**COUNTY OF VENTURA
PUBLIC WORKS AGENCY**

Addendum No.1

Subject: **tšumaš Creek Improvements Hueneme Road to Upstream of Jane Drive.
Specification No. WP21-01; Project No.: 82323
Bids to be Opened Thursday, October 15, at 2:00 PM**

FIGURE B
ADDENDUM 1
EXHIBIT D

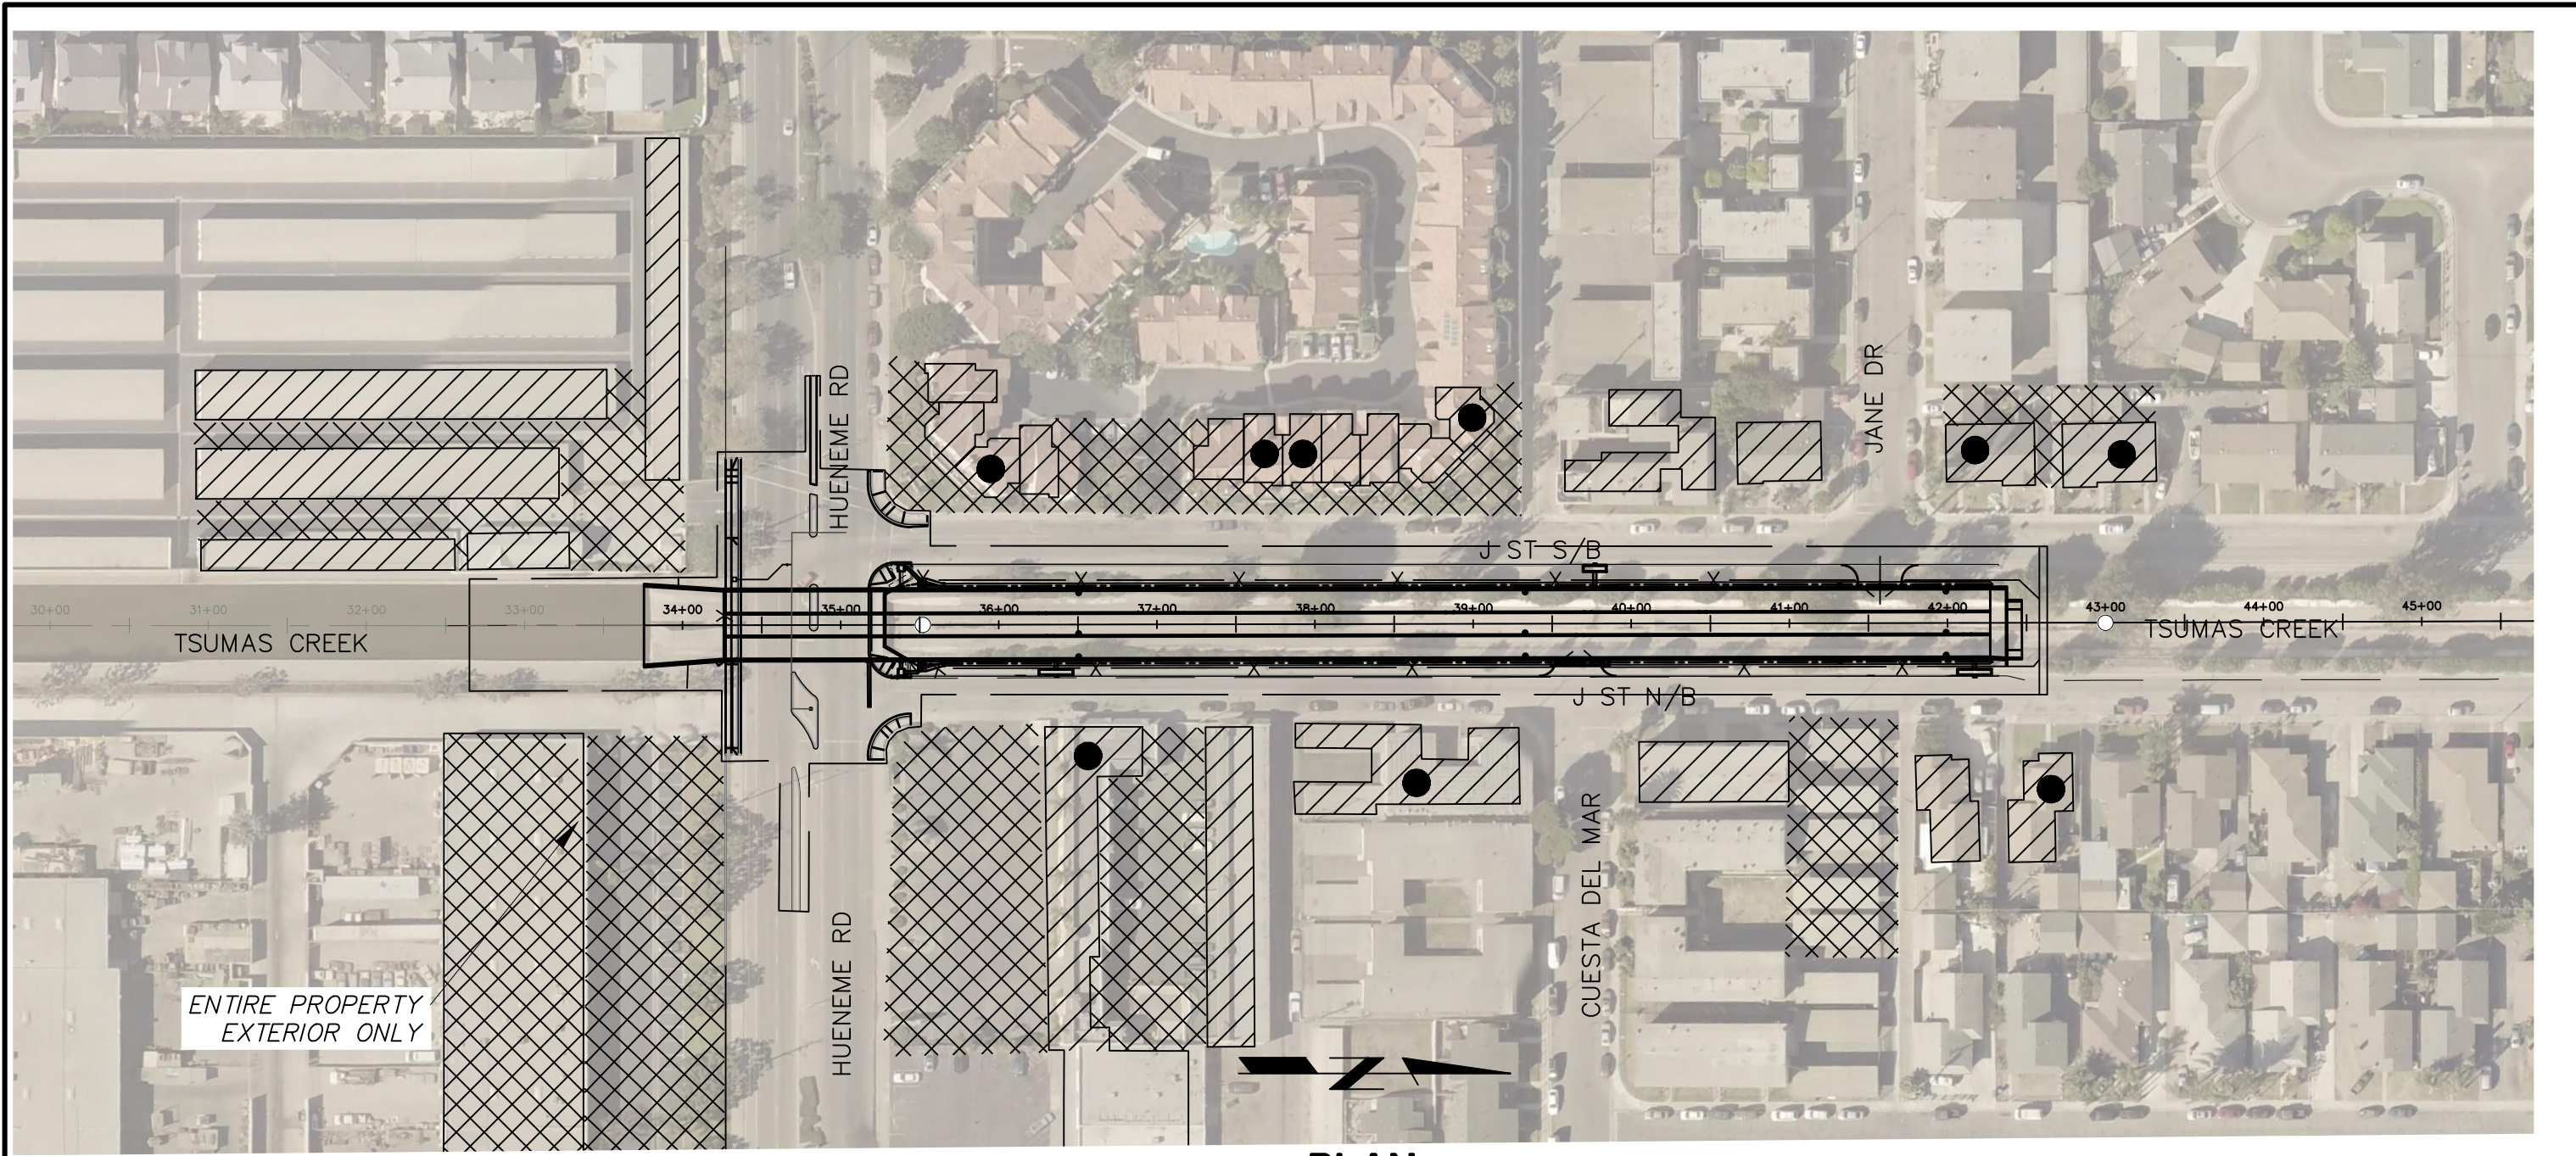
6. Replace Figure B – Potential Staging Areas, with the attached revised Figure B which shows an additional potential staging area.
7. Add "Figure C – AUDIO-VIDEO COLOR TAPING PARCELS"

**TŠUMAŠ (CHUMASH) CREEK IMPROVEMENTS
AUDIO-VIDEO COLOR TAPING PARCELS
FIGURE C**

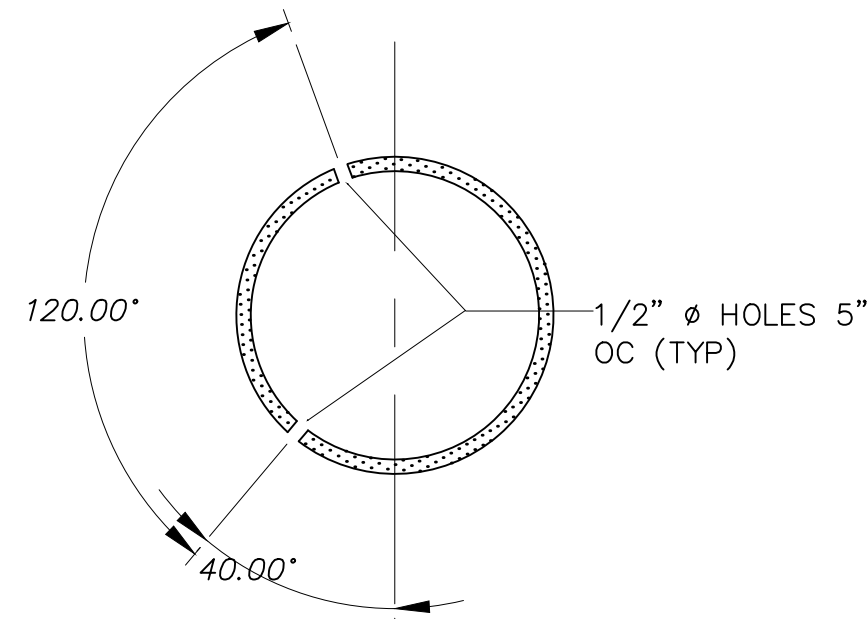
4. At the end of 1000-30, **AUDIO VIDEO COLOR TAPING**, Recording Conditions, add "The areas to perform Audio-Video Color Taping are shown in Figure C."

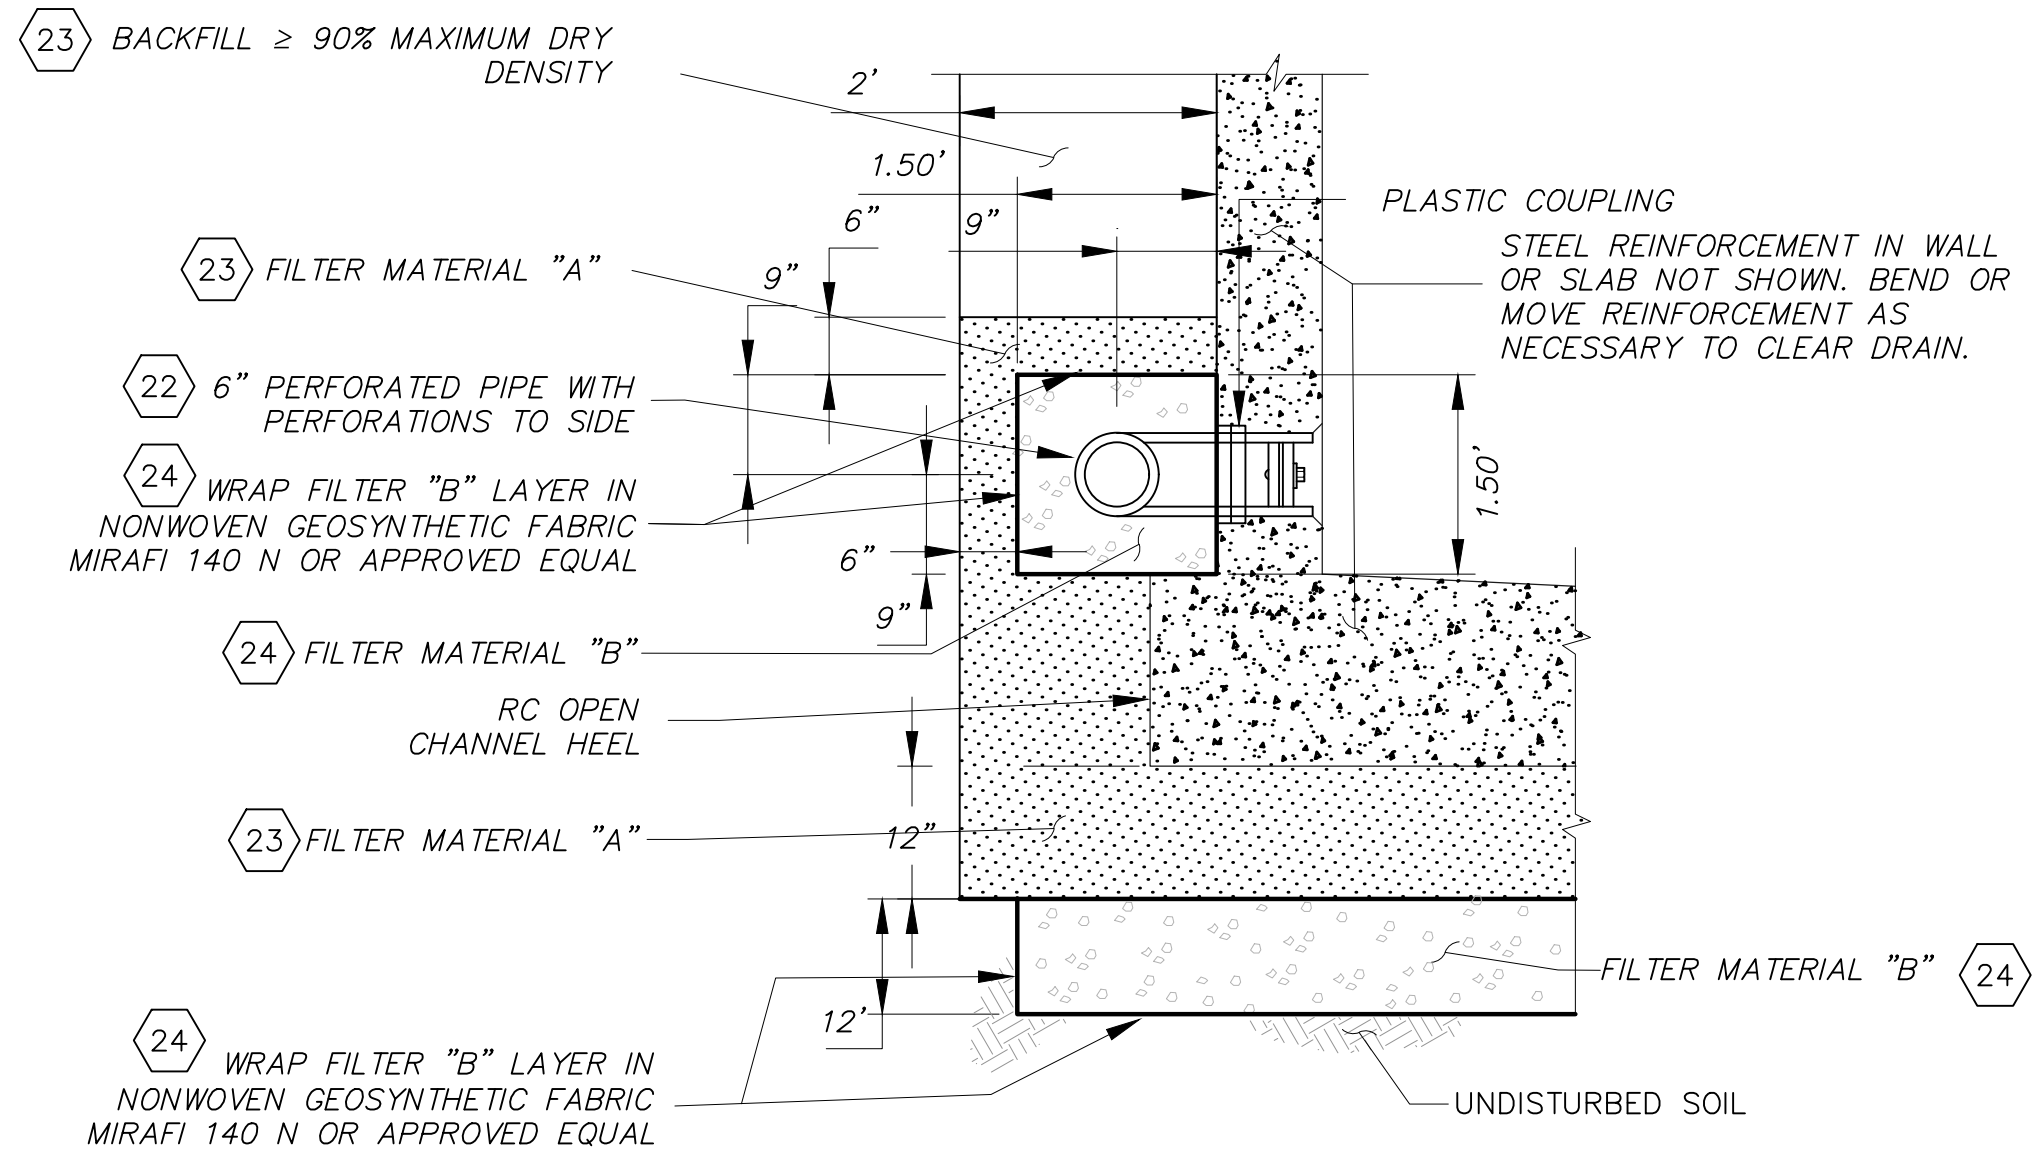
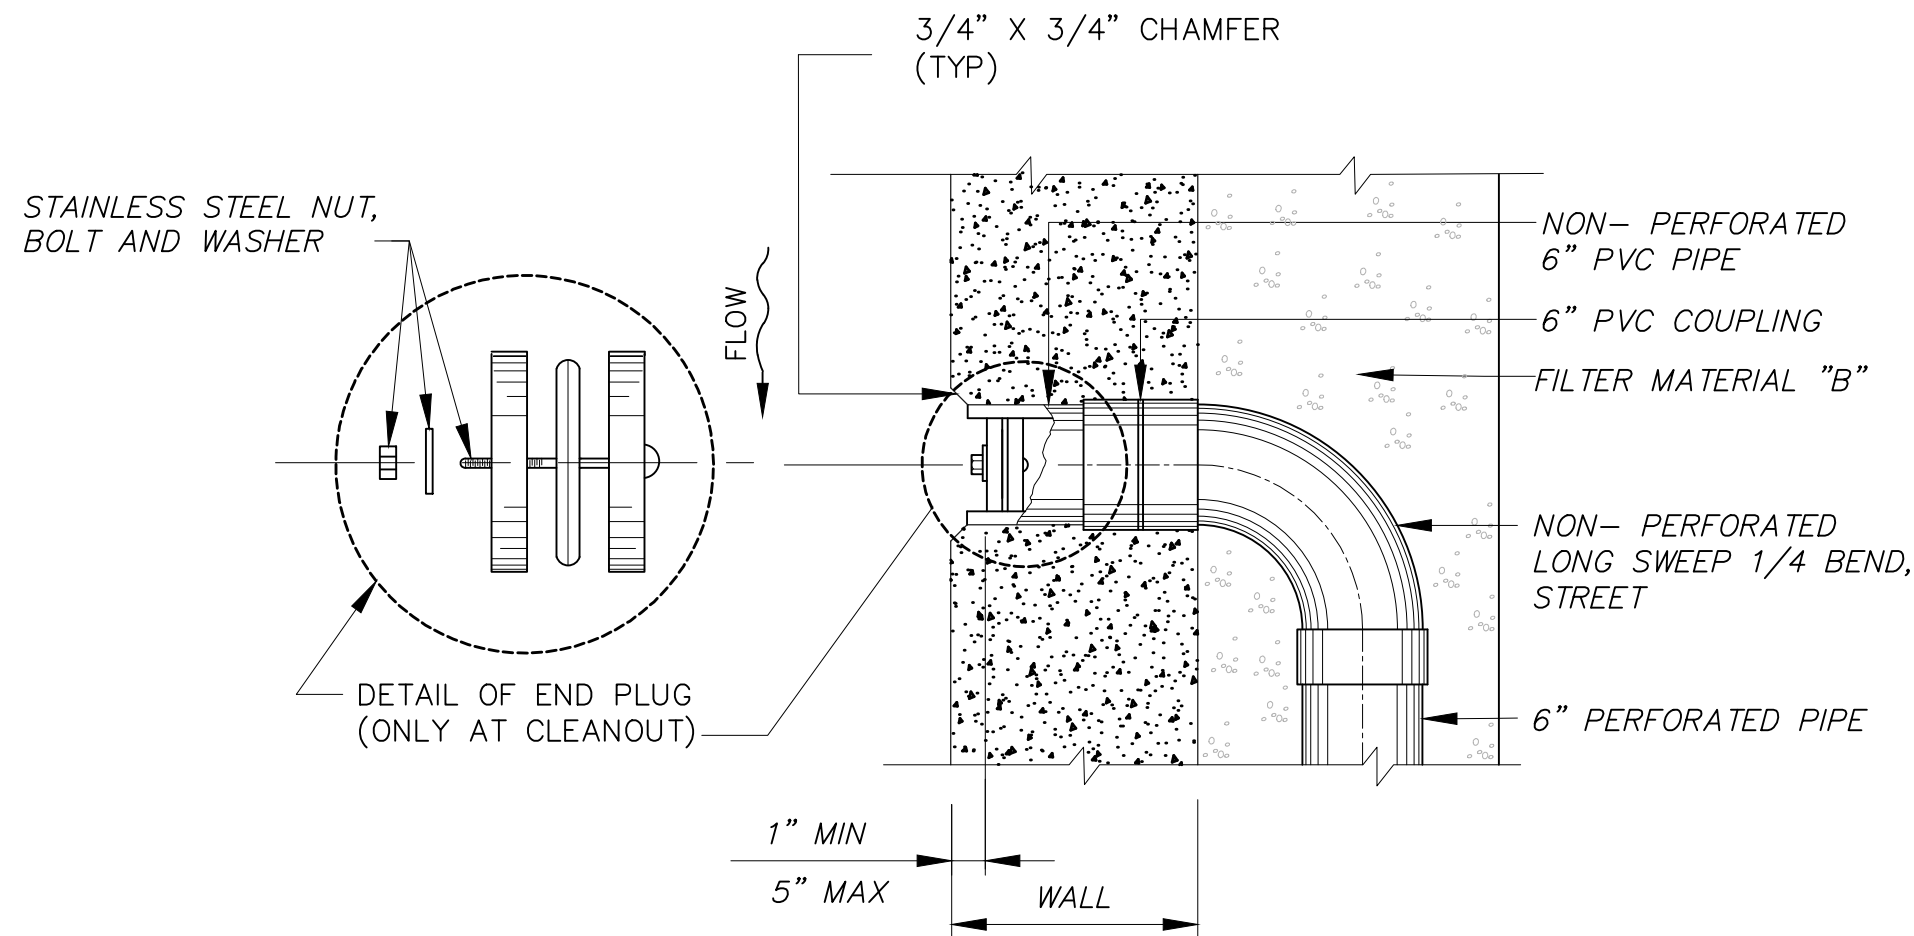
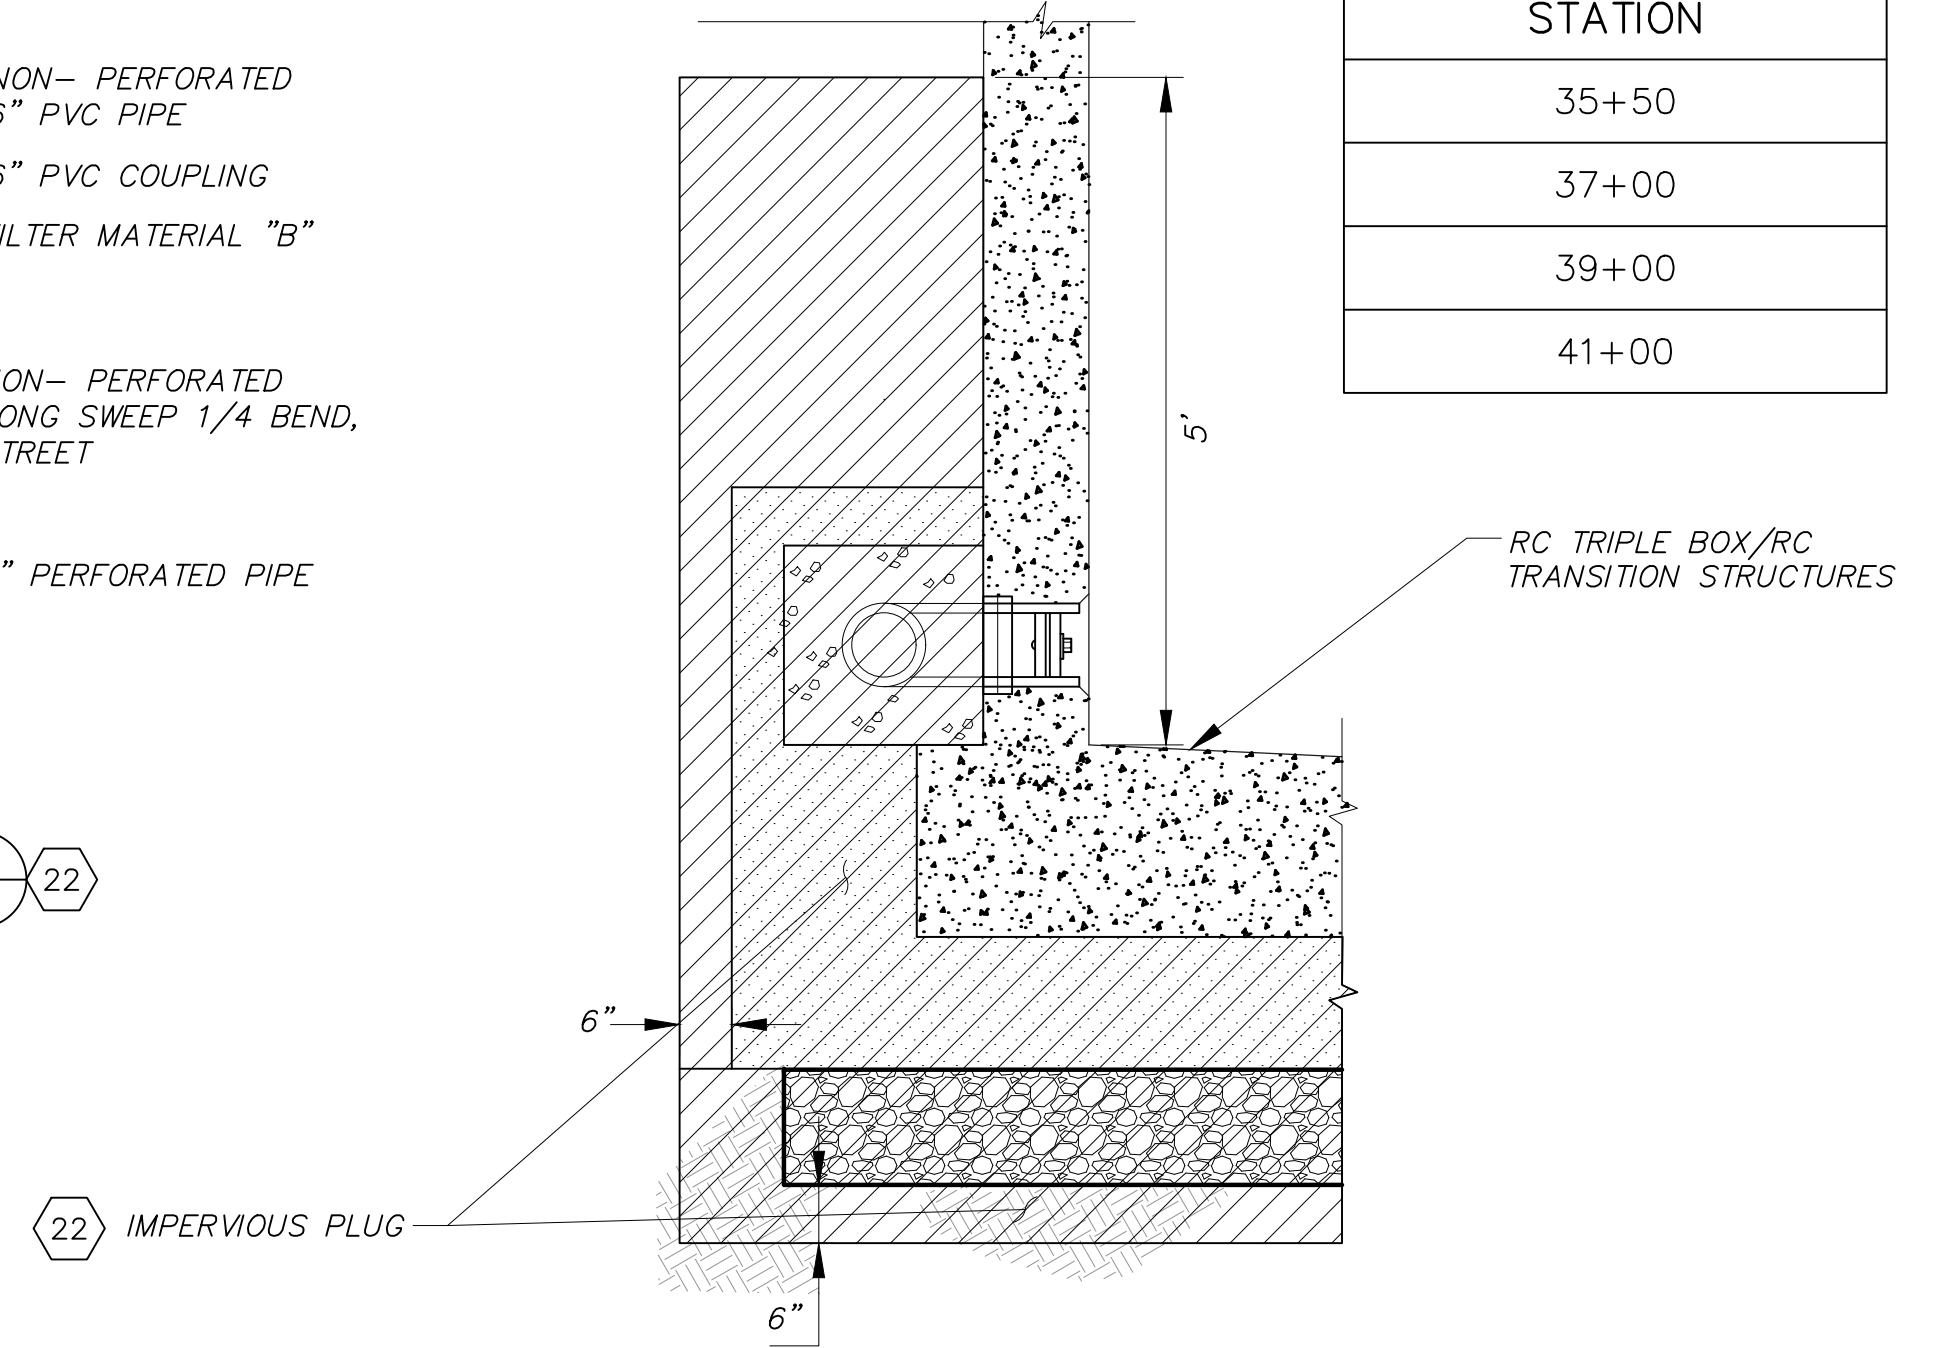
8. Replace sheet 11 OF 30, "SUBDRAIN DETAILS" with the attached, revised sheet 11 OF 30 to update the subdrain detail.
9. Replace sheet 24 OF 30, "CROSS SECTIONS STA 33+50 TO 37+00" with the attached, revised sheet 24 OF 30 to update with the new subdrain detail.
